FINAL PHASE I
CONTAMINATION ASSESSMENT REPORT
SITE 36-3: INSECTICIDE PIT
(Version 3.3)

APPENDIX 36-3-C
COMMENTS AND RESPONSES

Re: Rocky Mountain Arsenal (RMA),
Review of Final Phase I CAR Report for
Task 1, Site 36-3 Insecticide Pit

RESPONSES TO ENVIRONMENTAL PROTECTION AGENCY COMMENTS
ON THE FINAL TASK 1 REPORT
SITE 36-3: INSECTICIDE PIT

Figure 36-3-6
PHASE I INVESTIGATION,
BORING LOCATION MAP,
SITE 36-3

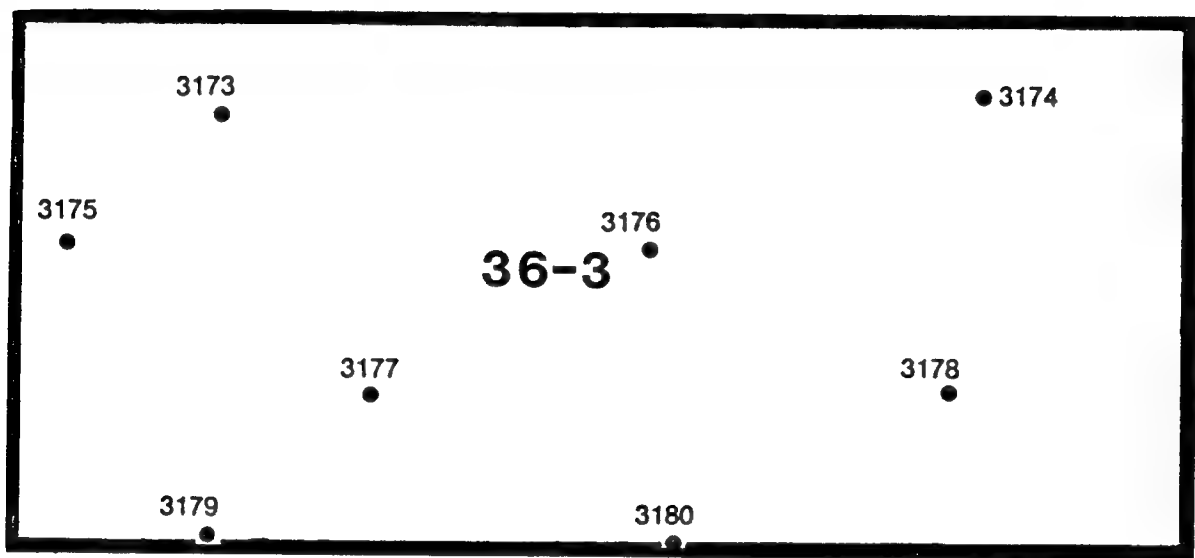
Comment_1:

Figure 36.3-6 [sic] should show the location of trenches based on aerial photos.

Response:

The trench locations were not placed on the figure due to the complex nature of the site which made such a presentation confusing and potentially misleading. The geophysical investigation generally detected high response levels and intense anomalies, such that it was very difficult to delineate trench and intertrench material. Maps presented in the geophysical report display these results, and explain that no direct correlation between trenches indicated on aerial photographs and geophysical anomalies was possible due to these uncertainties. The proposed investigation of suspected trench locations is based on the chemical and geophysical data. Further attempts to map trench locations will be made when additional data is gathered through Phase II borings.

Figure 36-3-7
PHASE I INVESTIGATION,
CHEMICAL ANALYSIS
RESULTS, SITE 36-3
SOURCE: ESE, 1987

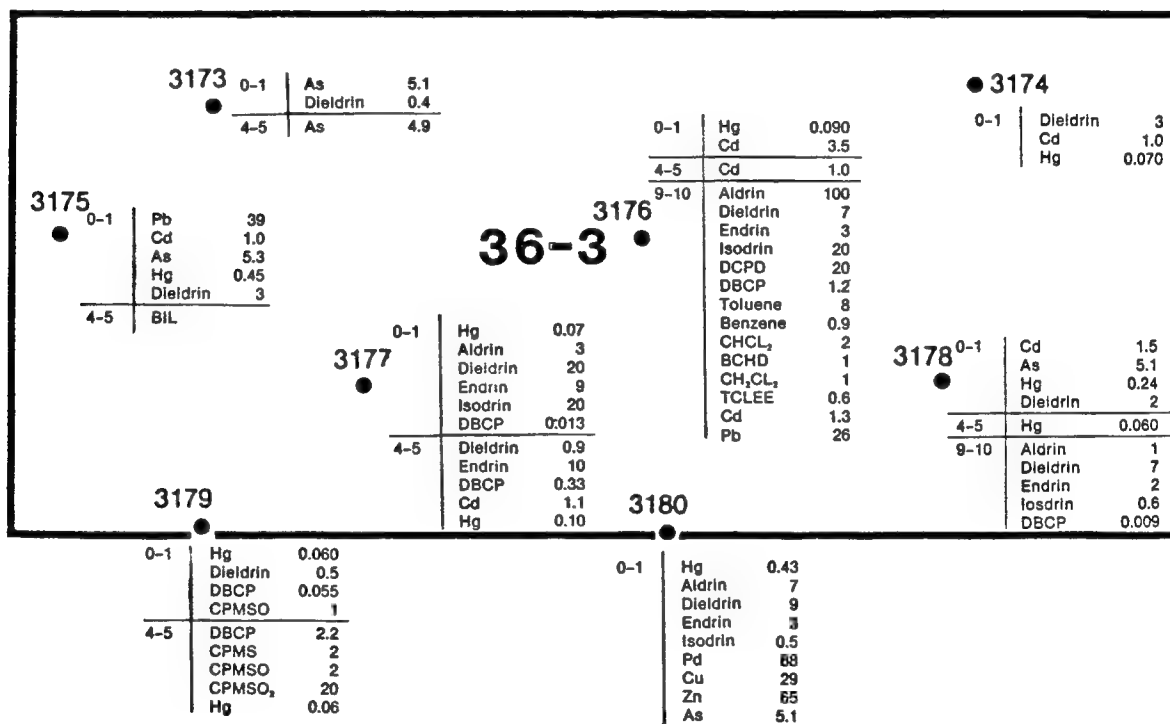
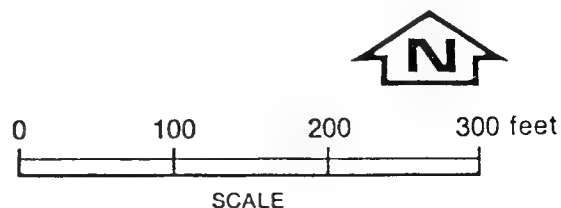
7. P. 36-3-22 Figure 36-3-10 should be corrected to show contaminants at or in excess of the revised indicator levels for metals.
8. P. 36-3-20 Table 36-3-3 should differentiate when samples are not analyzed for a particular class of organic chemicals such as volatiles.

7. 36-3-22 The figure has been revised as requested and now shows values within or above the established indicator ranges.
8. 36-3-20 The table has been revised as requested to clearly indicate when samples were not analyzed and when analysis was performed but no detections were made.

Figure 36-3-8
PROPOSED PHASE II INVESTIGATION,
BORING LOCATION MAP, SITE 36-3
SOURCE: ESE, 1987

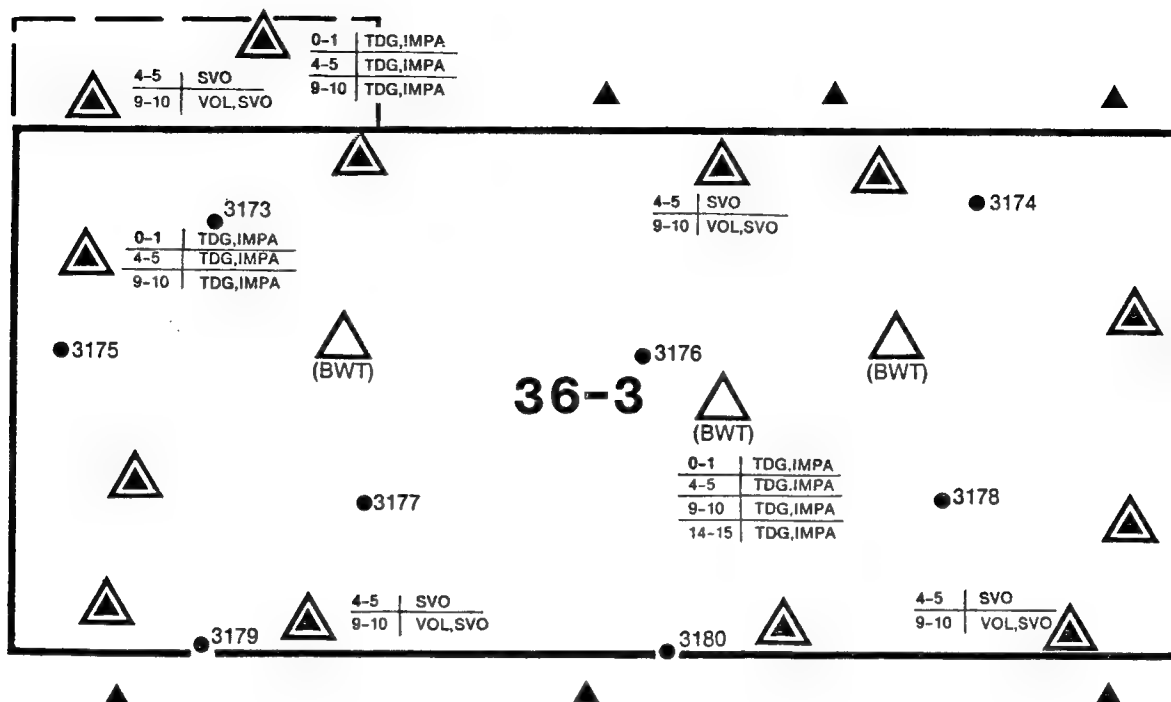
8. P. 36-3-27 First full paragraph. The statement that there were no high concentrations of contaminants detected in borings 3175, 3176, and 3177 is questionable.
9. P. 36-3-33 Arsenic should be added to list of analytes for shallow intervals. All borings should be to the 10 or 15 ft level.

7. P. 36-3-23 The text has been revised to eliminate vague statements and to note specifically the occurrence and distribution of various analytes.
8. P. 36-3-27 The boring numbers referenced were incorrect and have been revised.
9. P. 36-3-33 We do not see adequate justification for expanding the analytical list to include arsenic based on the Phase I data, which showed all arsenic values to be at the lower end of the indicator range. Selected boring depths have been extended, with some extending to 15 ft, which is below the water table contact.
